**Exhibition of SSD 8614 – Hurlstone Agricultural High School (Hawkesbury), Richmond
Western Sydney University Campus, 2 College Street, Richmond**

Attachment 1 – OEH comments on SSD 8614 – Hurlstone Agricultural High School (Hawkesbury), Richmond Western Sydney University Campus, 2 College Street, Richmond

Figure 1. Proposed development footprint and mapped PCTs within the Subject Site

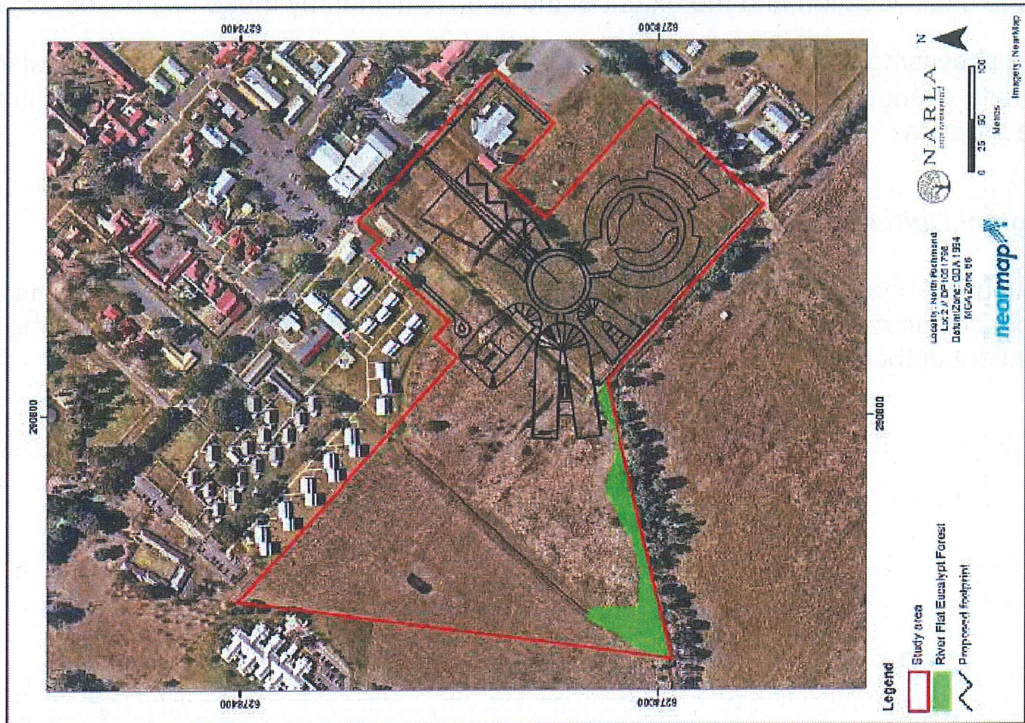
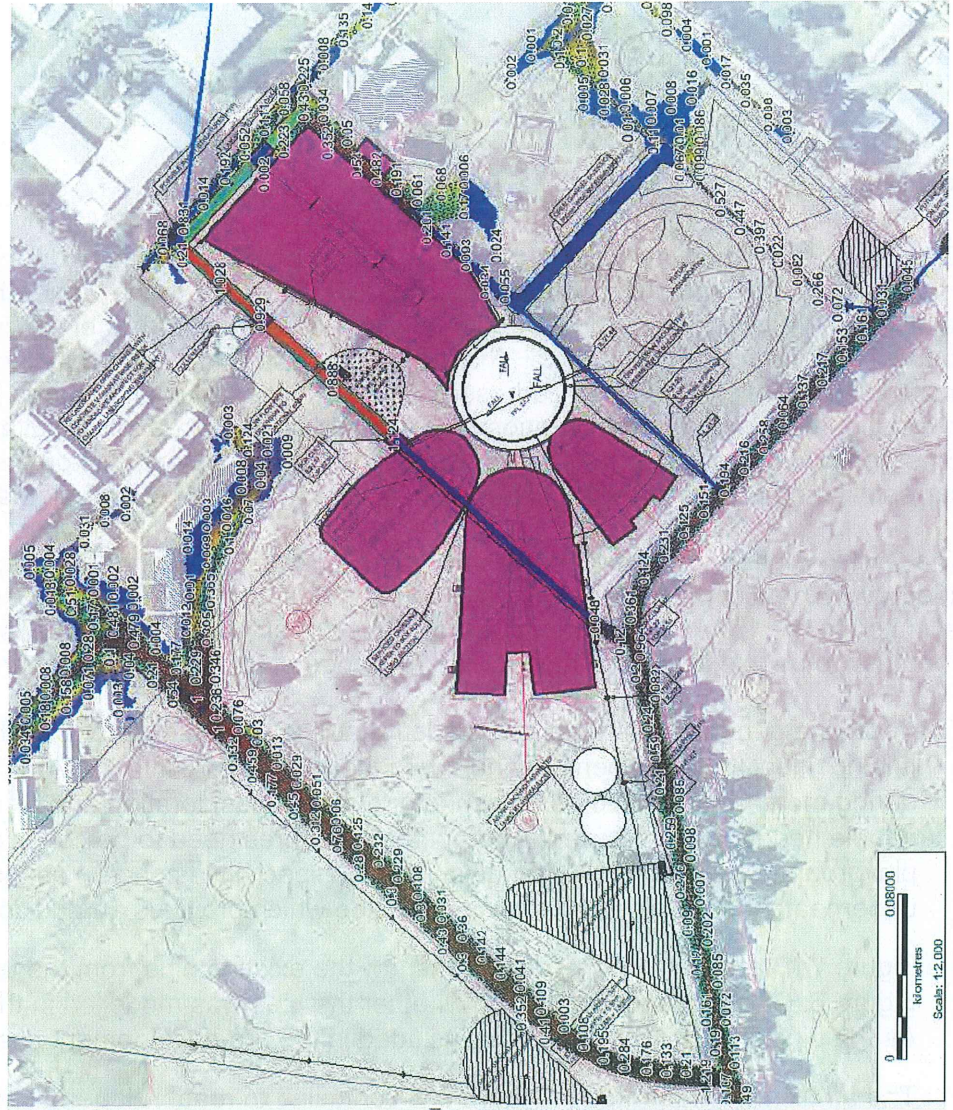
The Biodiversity Assessment Report (BAR) prepared by Narla Environmental Pty Ltd dated December 2017 identifies the endangered ecological community (EEC), River Flat Eucalypt Forest as being present on the site. This is shown highlighted in green in Figure 1 extracted below. Although there appear to be no direct impacts on this EEC from the school building footprint, there is no consideration in the Biodiversity Assessment Report of the impacts on this EEC from the proposed on-site detention (OSD) system and following works that are located in the vicinity of the EEC:

- proposed above ground 3,200sqm OSD system
- 2x above ground tanks
- culvert and
- 130m² bioretention system

Also, the Arborists report identifies that Trees 4 to 14 within the EEC area of River Flat Eucalypt Forest are to be retained. It is unclear whether the proposed OSD system will impact on the Tree Protection Zones. The scale of this proposal makes it likely that there will be impacts on the EEC (either directly or indirectly).

OEH requires that a Biodiversity Assessment Report be submitted that assesses the site and proposal in accordance with FBA. While the proponent's ecological consultants may have considered that there was no native vegetation being impacted, and therefore that the FBA does not need to be applied, OEH consider that the OSD works are likely to impact on the EEC. OEH therefore requires the preparation of a BAR that considers the impacts from the OSD and related stormwater/site works, unless it can be demonstrated there will not be any direct or indirect impacts from the site work.
